**UNIFORM STANDARD DRAWINGS
CLARK COUNTY AREA**

VOLUME II - YEAR 2010 REVISIONS

SPECIFICATION REFERENCE		CLARK COUNTY, NEVADA	
		SIZE "R" CABINET	
		DATE 05/20/10	DWG. NO. 404.307

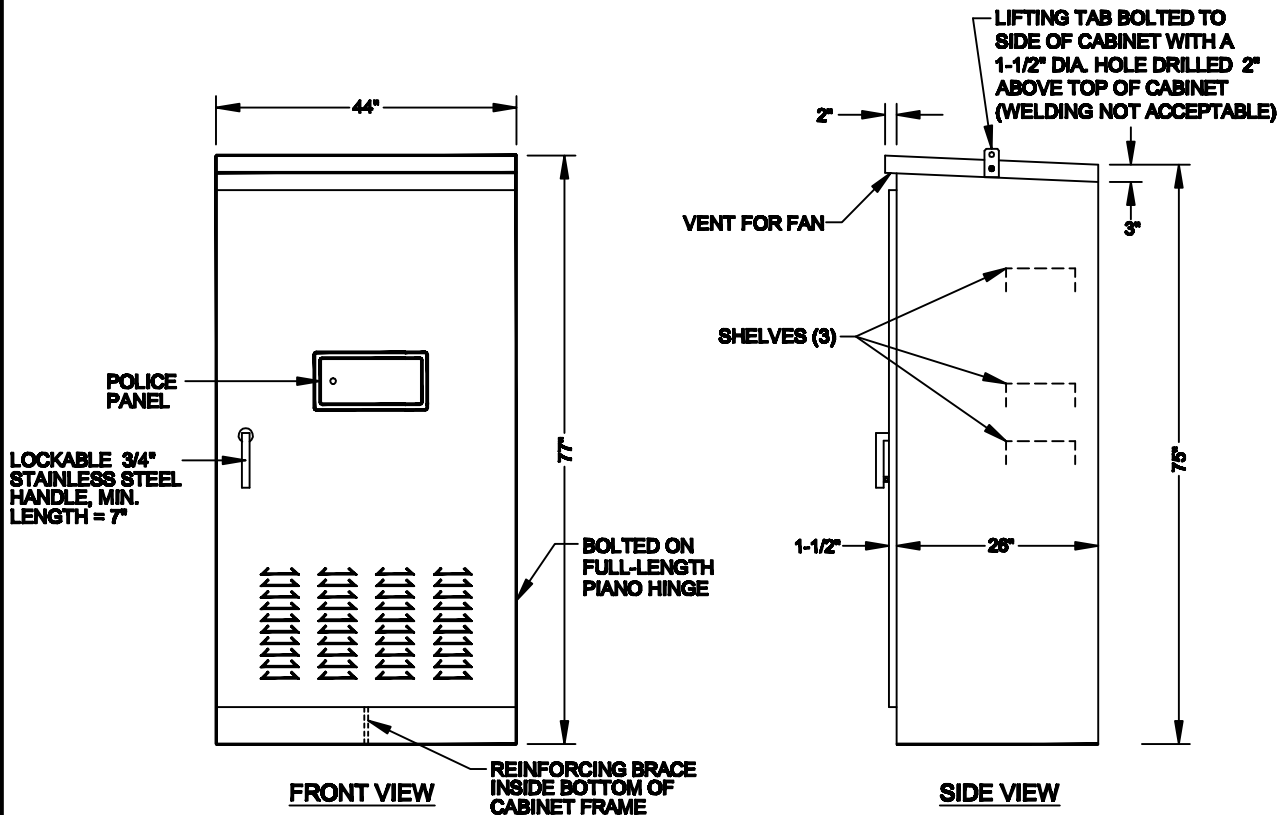
DRAWING NUMBER	TITLE AND REVISION SUMMARY	EFFECTIVE DATE
404.307	"Type VIII Cabinet" - Revisions to modify dimensions and reinforcing details.	7/01/10
404.418	"Sign Mounting Illustration" - Revisions to sign bracket requirements.	7/01/10

SPECIFICATION REFERENCE		UNIFORM STANDARD DRAWINGS CLARK COUNTY AREA	
		POLE DRILLING DETAILS	
DATE	05/20/10	DWG. NO.	404.600

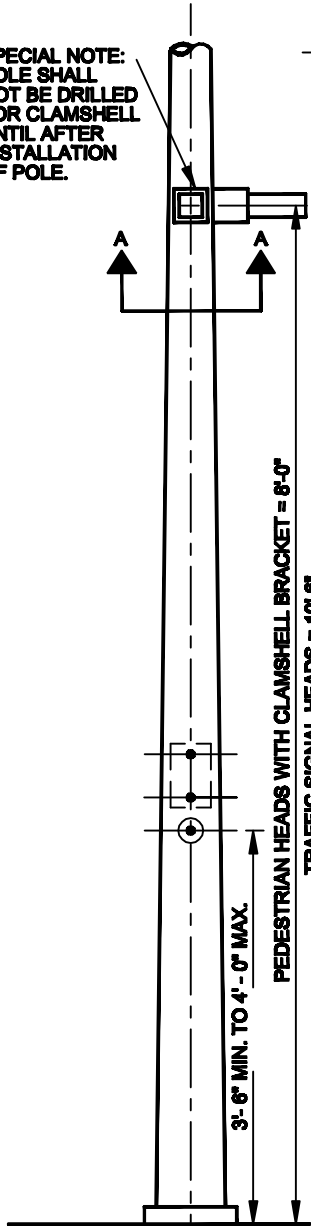
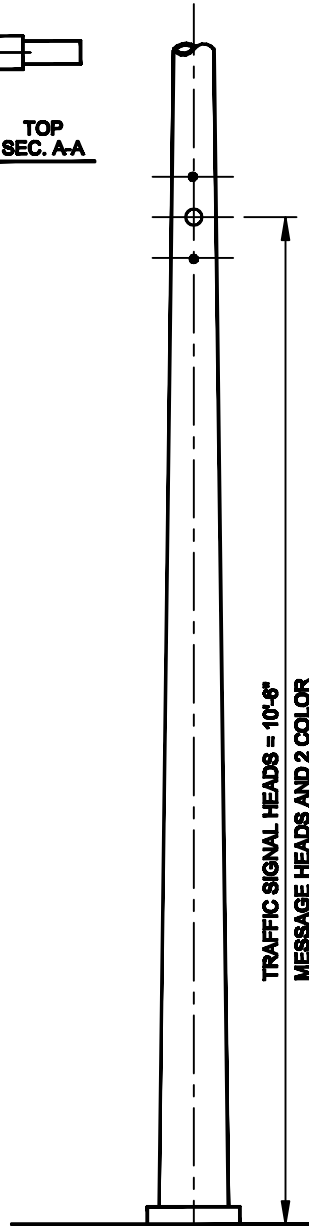
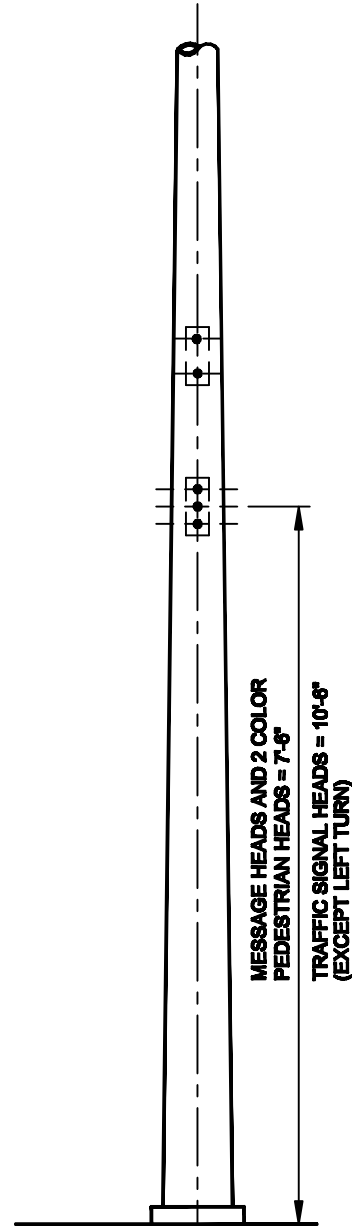
404.600	"Pole Drilling Details" - Revisions to dimensions for drill holes in poles.	7/01/10
404.903	"Louvered Backplate for 5 Section Signal Head" - Revisions to modify configuration of backplate.	7/01/10

SPECIFICATION REFERENCE		UNIFORM STANDARD DRAWINGS CLARK COUNTY AREA	
623	TRAFFIC SIGNAL & STREET LIGHTING	TYPICAL INTERSECTION ITS UNDERGROUND LAYOUT	
		DATE 05-20-10	DWG. NO. 404.1307

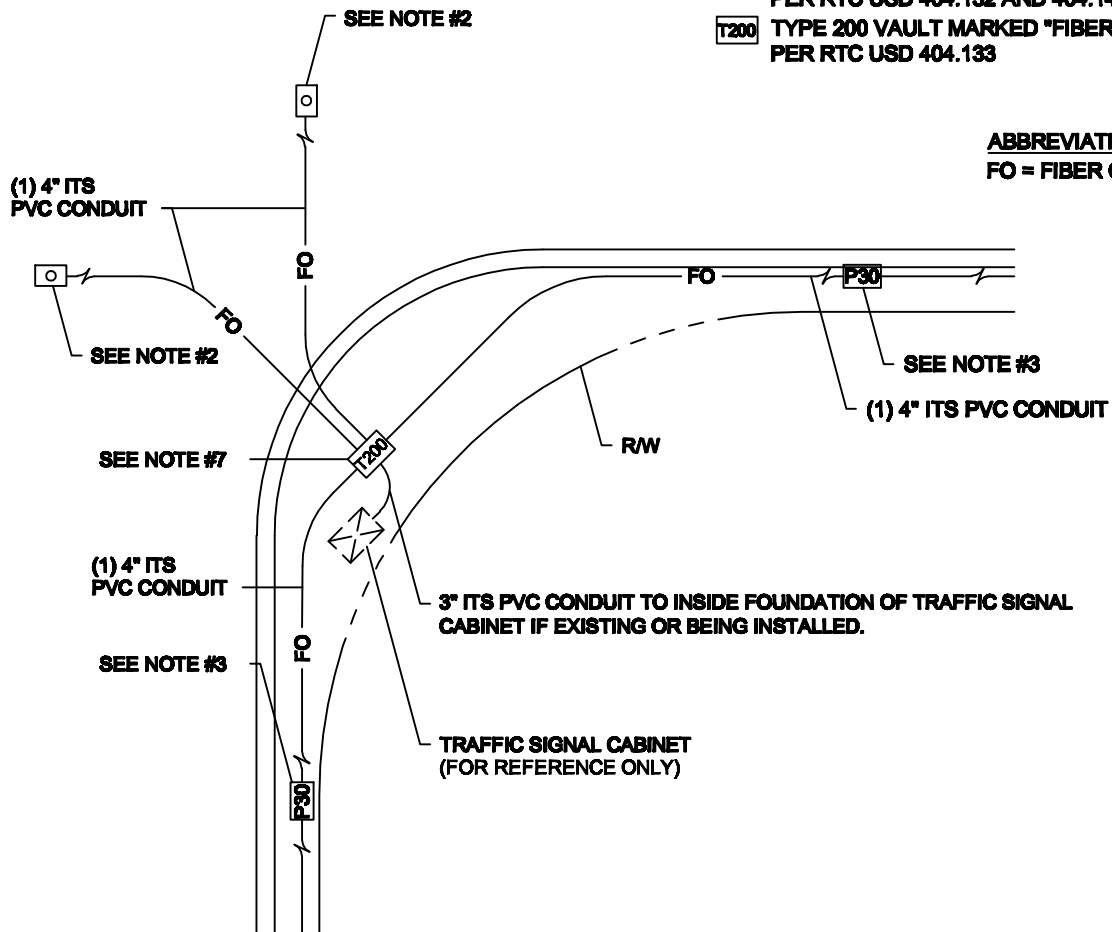
404.1307	"Typical Intersection ITS Underground Layout" - New standard drawing to clarify the placement of Intelligent Transportation System (ITS) conduits at intersections.	7/01/10

UNIFORM STANDARD DRAWINGS CLARK COUNTY AREA		
CLOSED CIRCUIT TELEVISION (CCTV) CAMERA		
DATE 04-08-10	DWG. NO. 404.1500	SHEET 1 OF 4

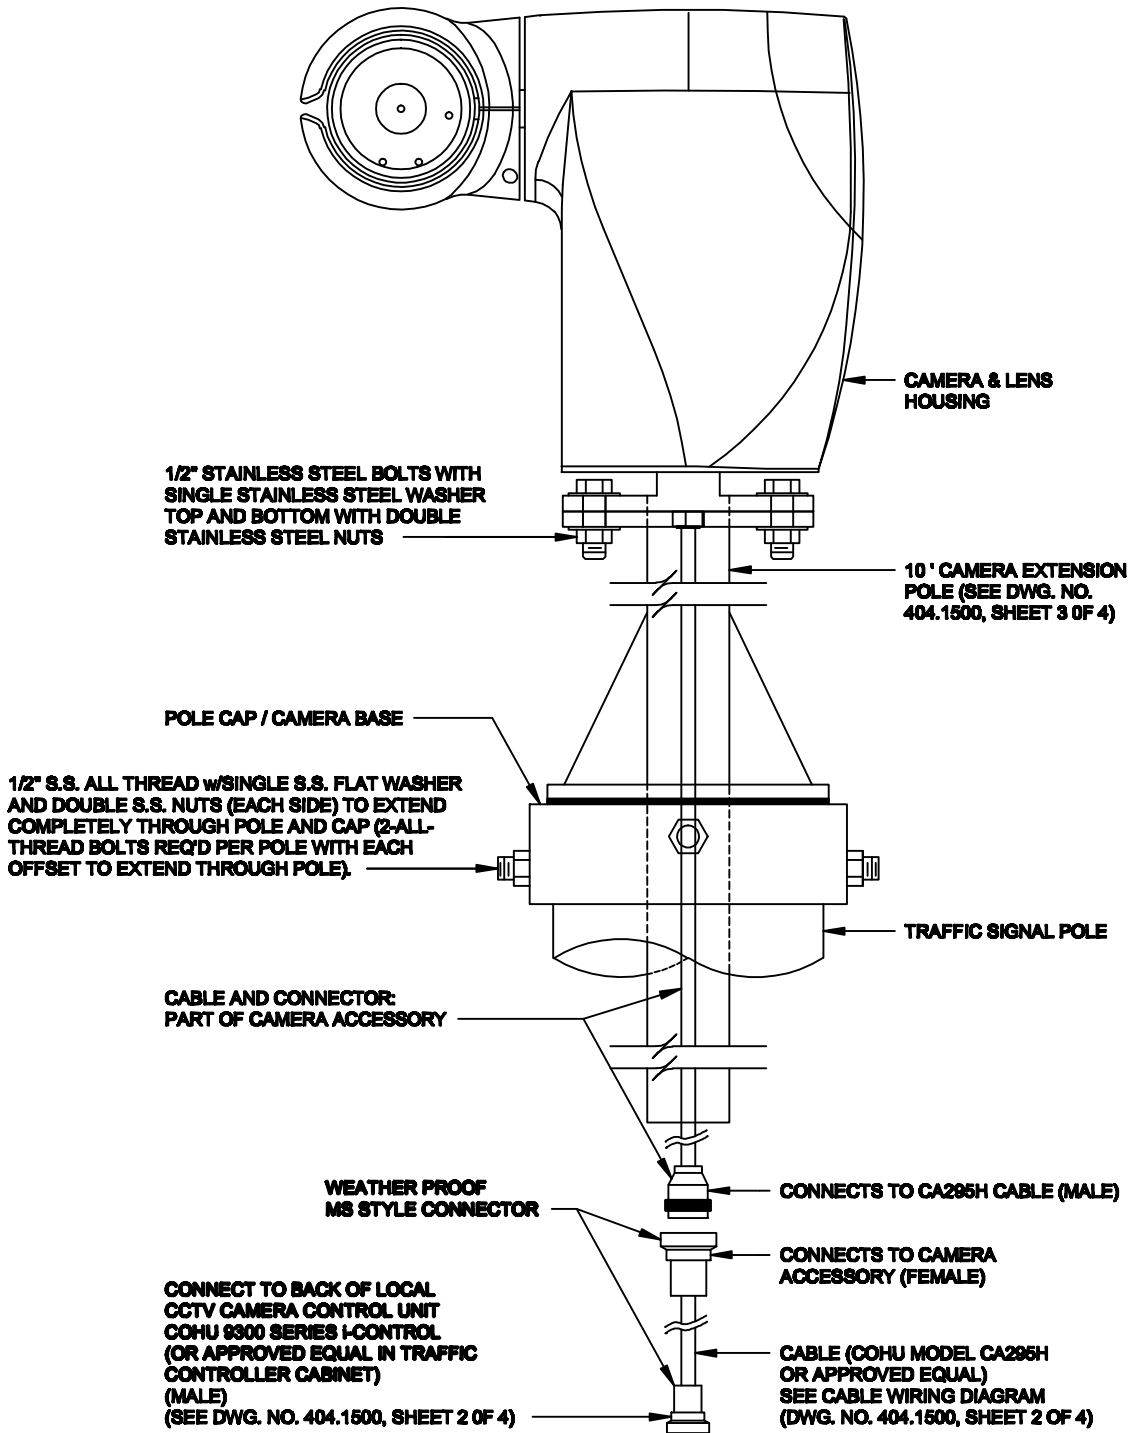
404.1500	"Closed Circuit Television (CTV) Camera"; "Closed Circuit Television Camera Control Unit and Cable Wiring Diagram"; "Camera Extension Pole"; "Camera Adaptor Stand" - Revisions to provide improved visibility for traffic incident monitoring and surveillance.	7/01/10

SPECIFICATION REFERENCE		UNIFORM STANDARD DRAWINGS CLARK COUNTY AREA		
681	FIBER OPTIC SPLICE AND DISTRIBUTION EQUIPMENT	COMMUNICATION DISTRIBUTION CABLE ASSEMBLY (CDCA) IN CABINET		
		DATE 04-08-10	DWG. NO. 404.1501	SHEET 1 OF 1

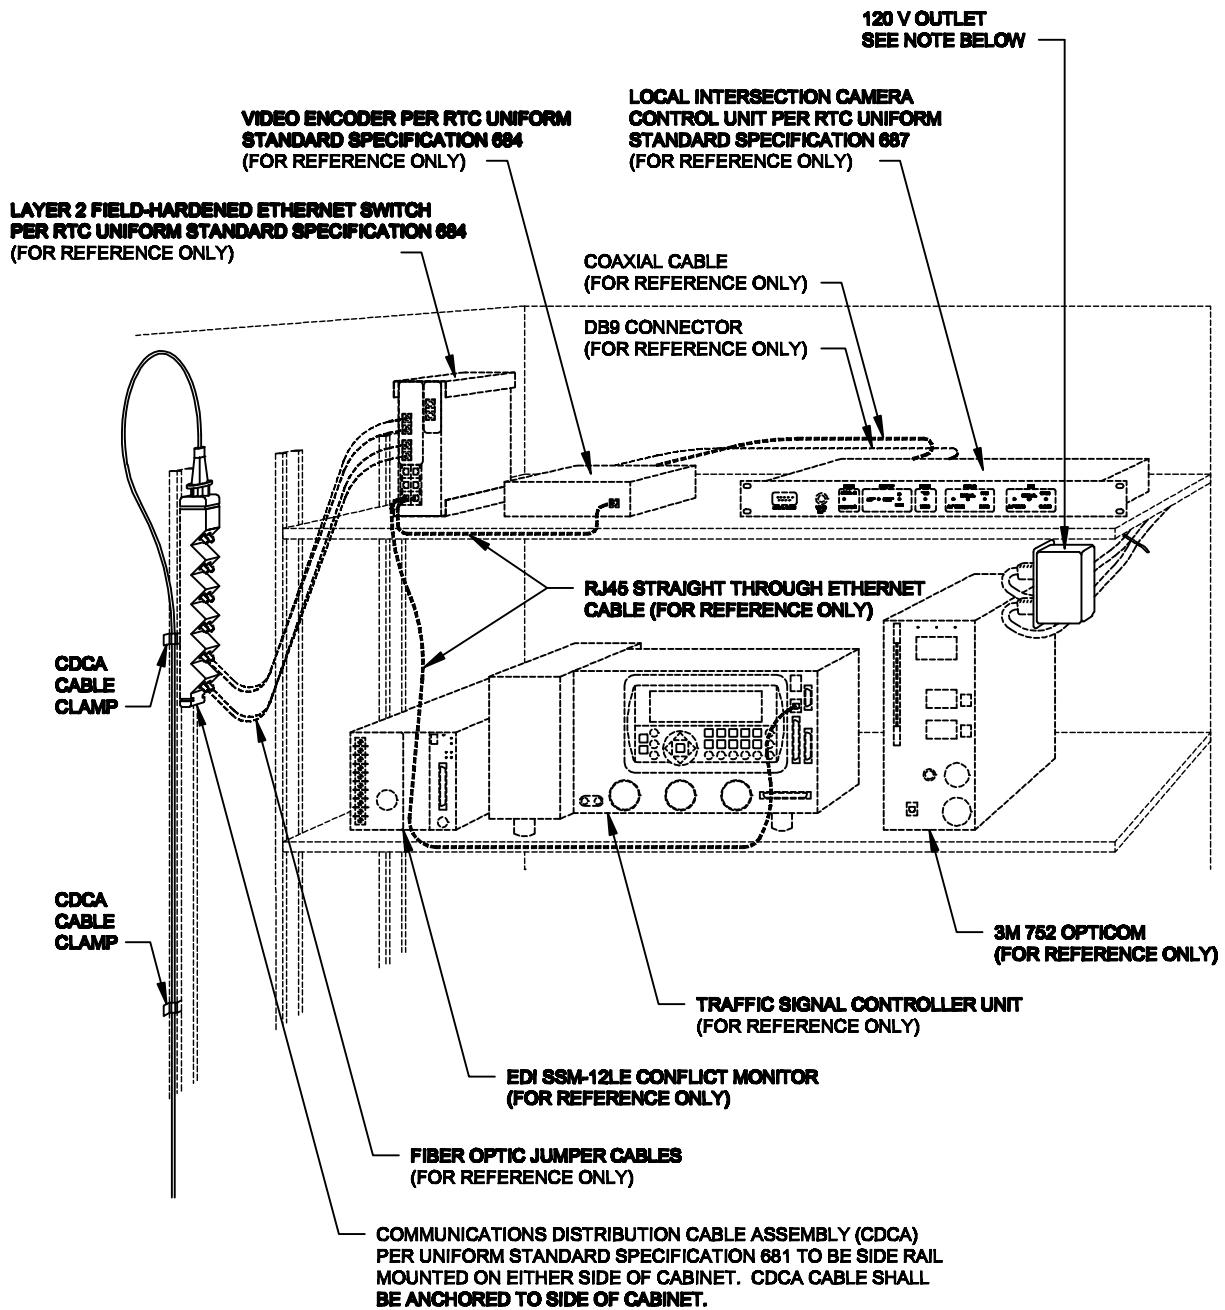
404.1501	"Communication Distribution Cable Assembly (CDCA) in Cabinet" - Revisions to show the CDCA placement detail in the cabinet.	7/01/10
